## Change Notification for MSD40NBT

December 3, 2013

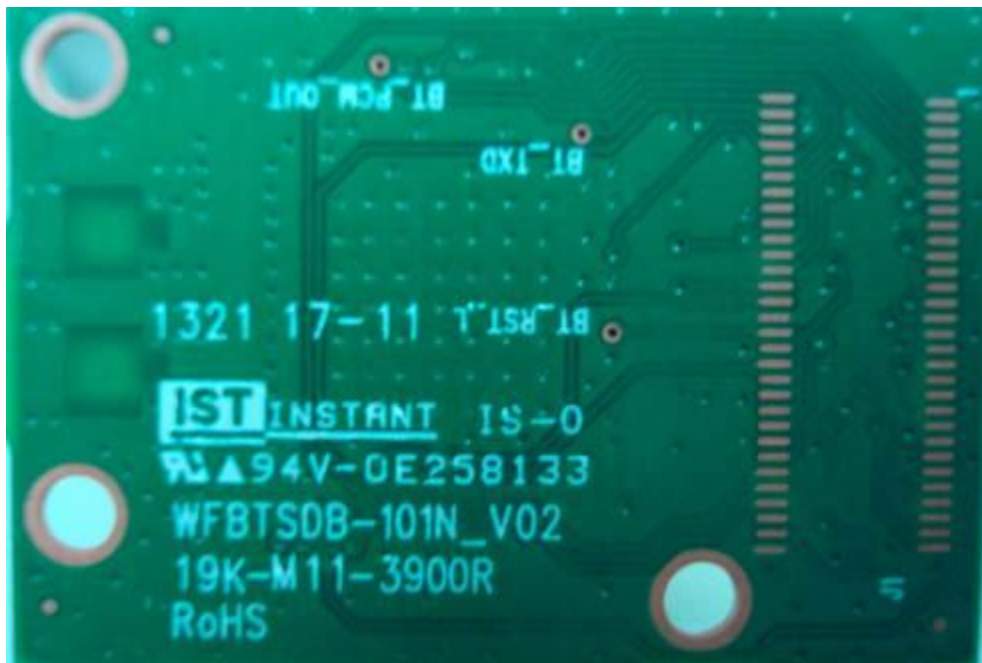
A limited quantity of the MSD40NBT, Rev 11, have printed circuit boards that were not manufactured correctly. The faulty printed circuit boards are labeled on the back with the manufacturers part number 19K-M11-3900R. (See image below) These boards have been shipping in limited quantity since July 2013. The signals BT\_LED\_ACTIVE (J1 Pin 11) and BT\_HOST\_WAKE (J1 Pin 7) are shorted to the 3.3 volt rail on the printed circuit board. These internal shorts will cause excessive current draw in the cases outlined below.

When BT Sleepmode is enabled and BT\_HOST\_WAKE is low, there is a 32mA increase in current consumption. Similarly, when the BT LED functionality is enabled and BT\_LED\_ACTIVE there is a 15mA increase in current consumption. These increases only occur if either BT Sleepmode or the BT LED is being actively toggled in software. By default, the Summit Client Utility (SCU) and Laird Connection Manager (LCM) software do not modify the states of these pins.

Laird has implemented quality procedures, including a new Design Rule Check (DRC) to avoid similar problems in the future. In addition, Laird has redesigned the MSD40NBT module to correct the issues with these output pins. MSD40NBT Rev 12 will correct this problem.
